Work Order ID 161174

Item Name: Aft Crosstube - Mid Height 206L / L1 / L3 / L4, Blue

DRAWING NO. D206-667-247
TITLE CROSSTUBE ASS'Y (206L MID AFT)

DRAWING NO. D206-667-247	TITLE CROSSTUBE ASS'Y (206L MID AFT)	REV. A	DART AEROSPACE LTD ENGINEERING ORDER		D.E.O. NO. D206-667-247-A-1	SHEET NO. SHEET 1 OF 1	SCALE NTS
DRAWN <i>Q</i>	CHECKED <i>ASS</i>	MFG. APPR. <i>AS</i>	APPROVED <i>IMP</i>		DE APPR. <i>#</i>		
DATE 11.07.15	DATE 11.07.20	DATE 11.07.21	DATE 11/07/21		DATE 11.07.21

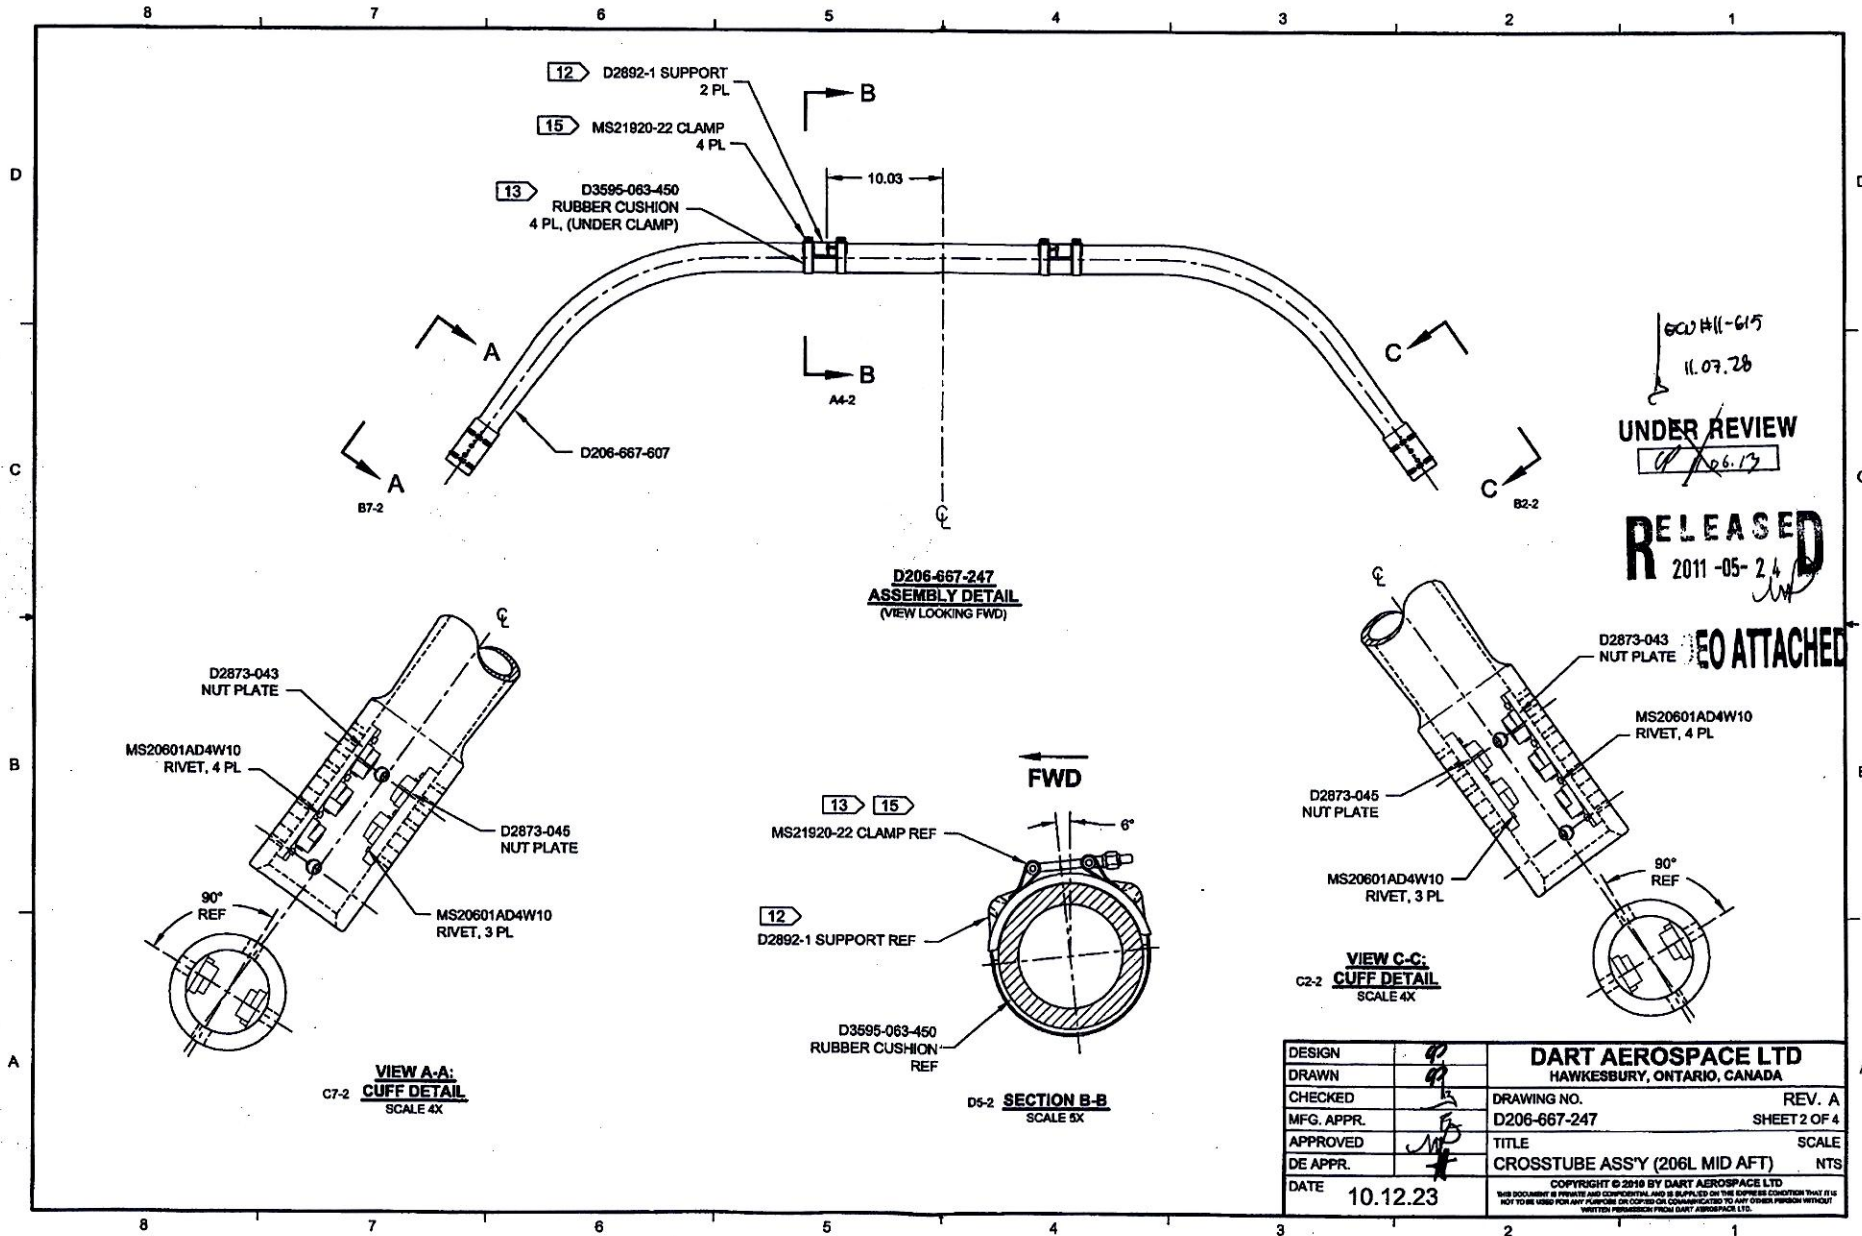
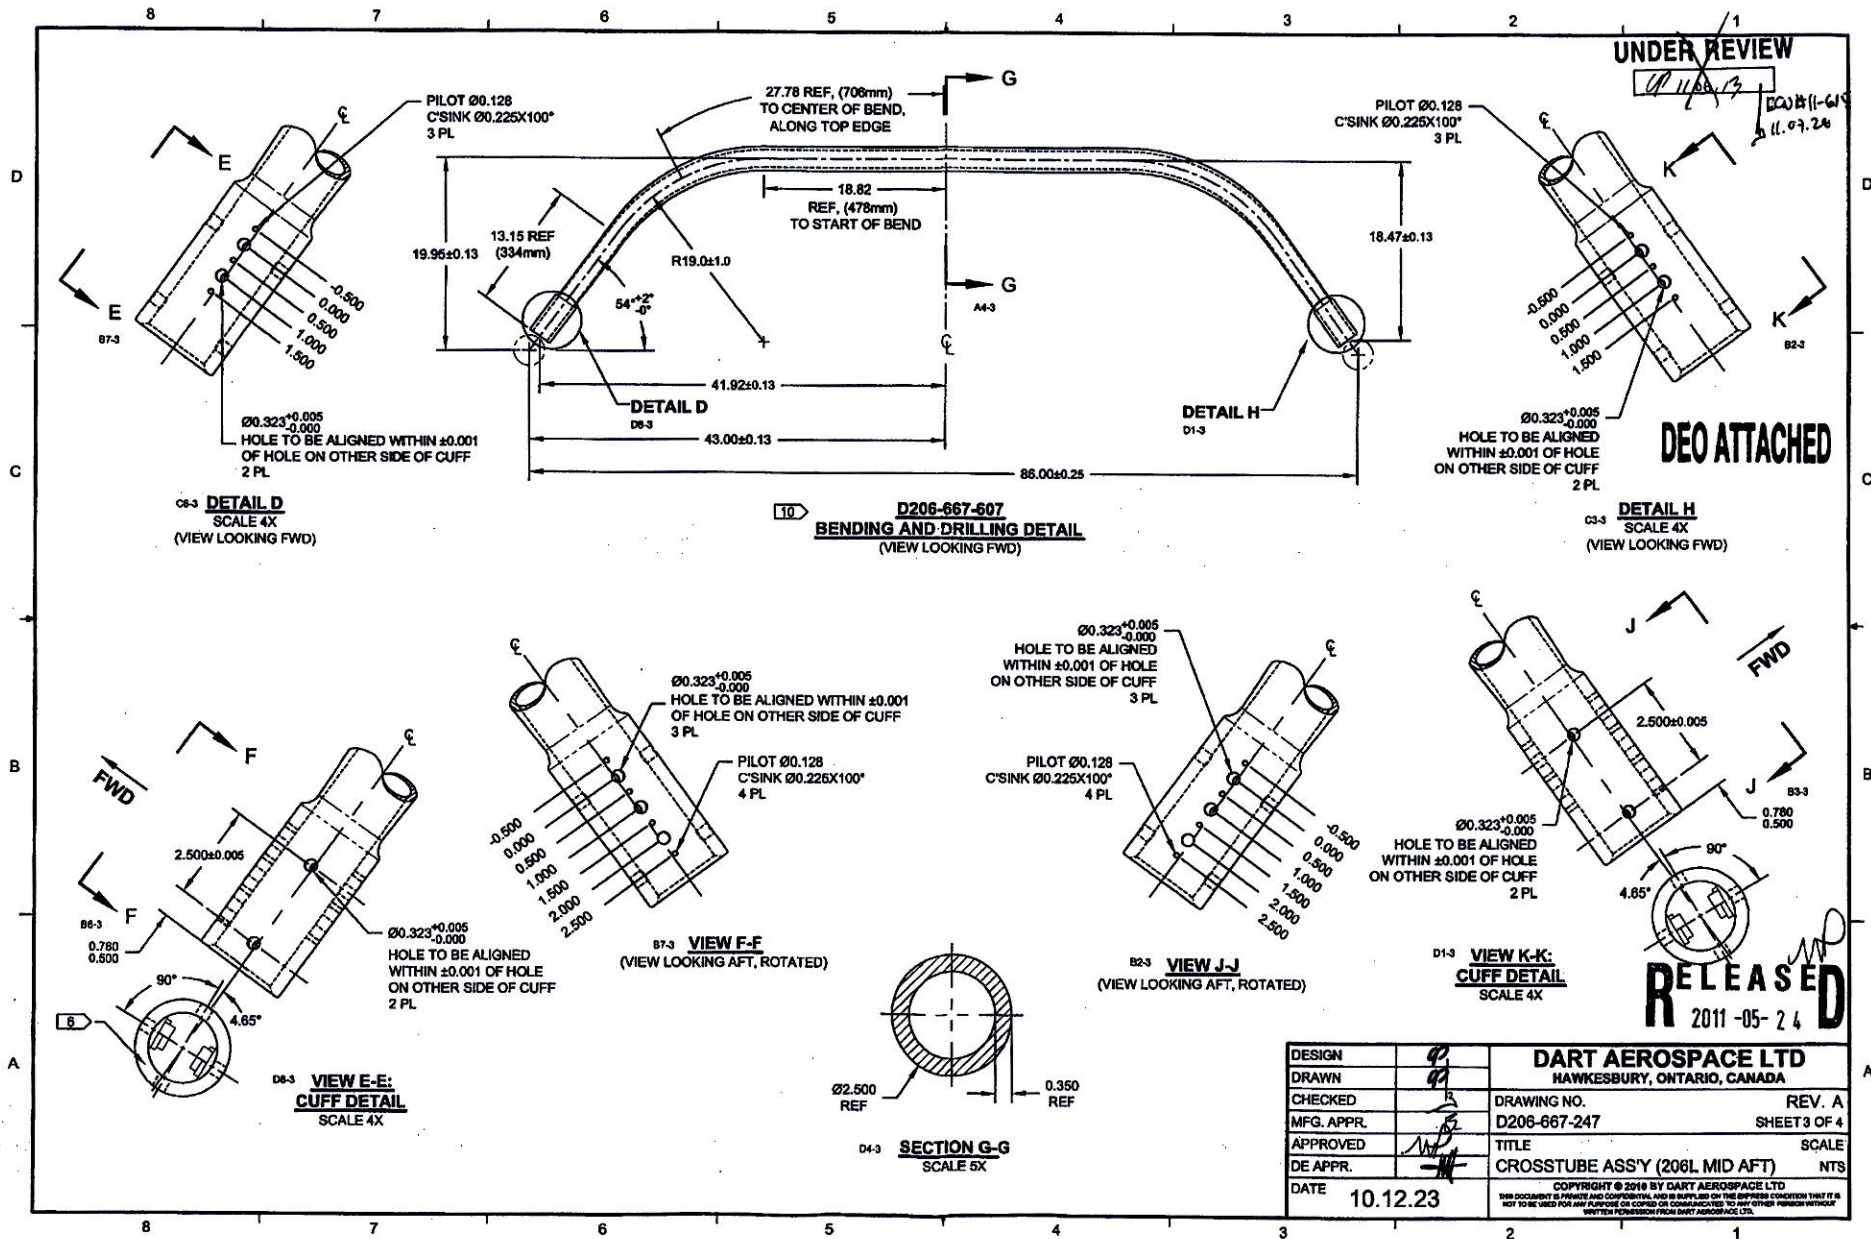
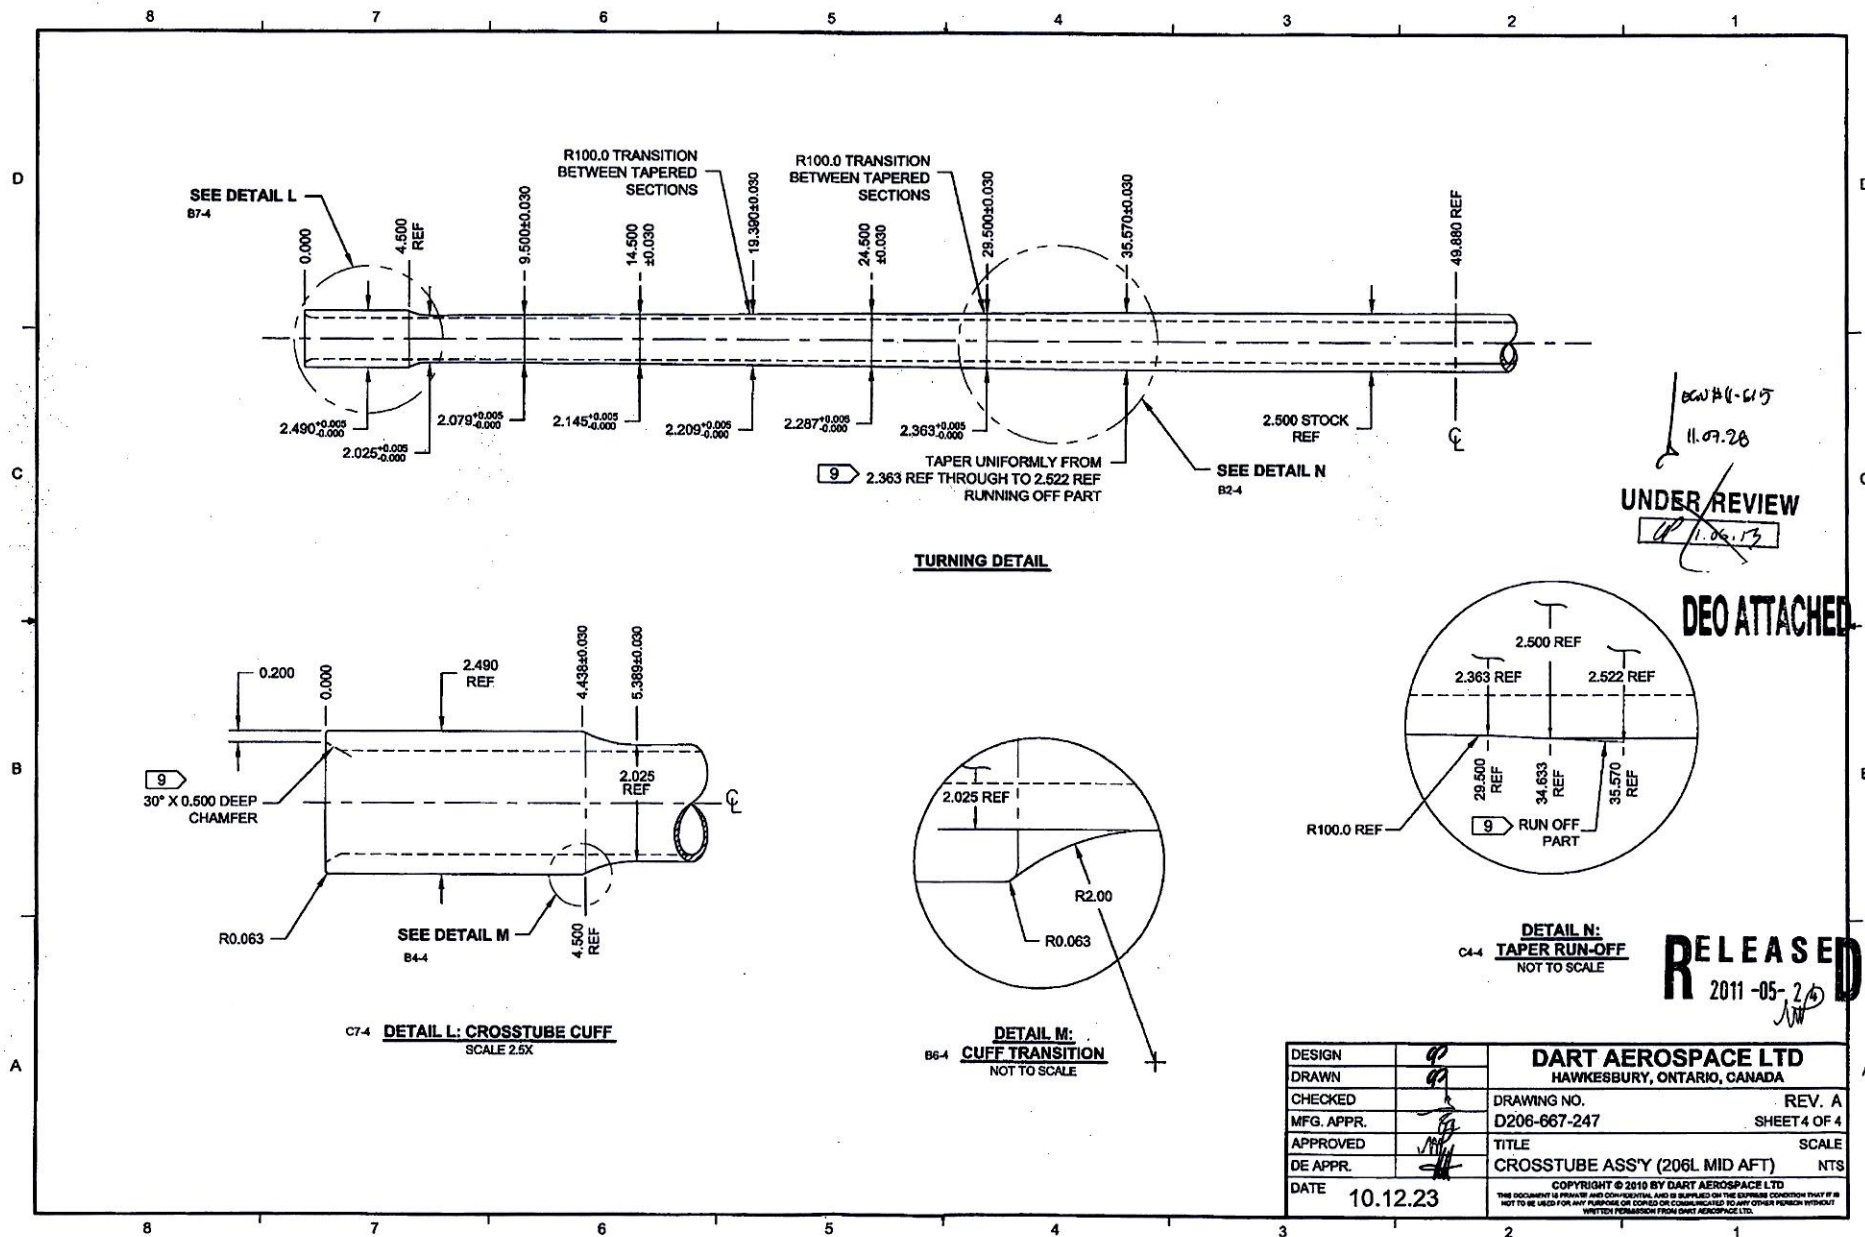
PURPOSE:

REPLACE MAGNOBOND WITH PROSEAL.

NOTE 12 & 15, SHEET 1 IS AMENDED AS FOLLOWS:

Item	Qty -247	Part Number	Description
9	A/R	PROSEAL 890 B-2	SEALANT, AMS-S-8802 CLASS B-2

- 12) TO INSTALL D2892-1 SUPPORT: ABRASE MATING SURFACE OF SUPPORT AND CROSSTUBE WITH 180-GRIT SANDPAPER AND REMOVE RESIDUE WITH MEK (OR EQUIVALENT). APPLY A 0.04" TO 0.07" THICK LAYER OF PROSEAL 890 CLASS B-2 (OR AMS-S-8802 CLASS B-2) SEALANT TO MATING SURFACE OF SUPPORT.
- 15) TORQUE CLAMPS 80 TO 100 IN-LB. ENSURE AT LEAST 1.5 THREADS SHOWING IN SAFETY AND THAT NUT HAS NOT BOTTOMED-OUT AFTER TORQUING. **PRIOR TO PACKAGING, RE-CHECK TORQUE ON CLAMPS AFTER PROSEAL 890 SEALANT HAS CURED FOR 72 HOURS.**
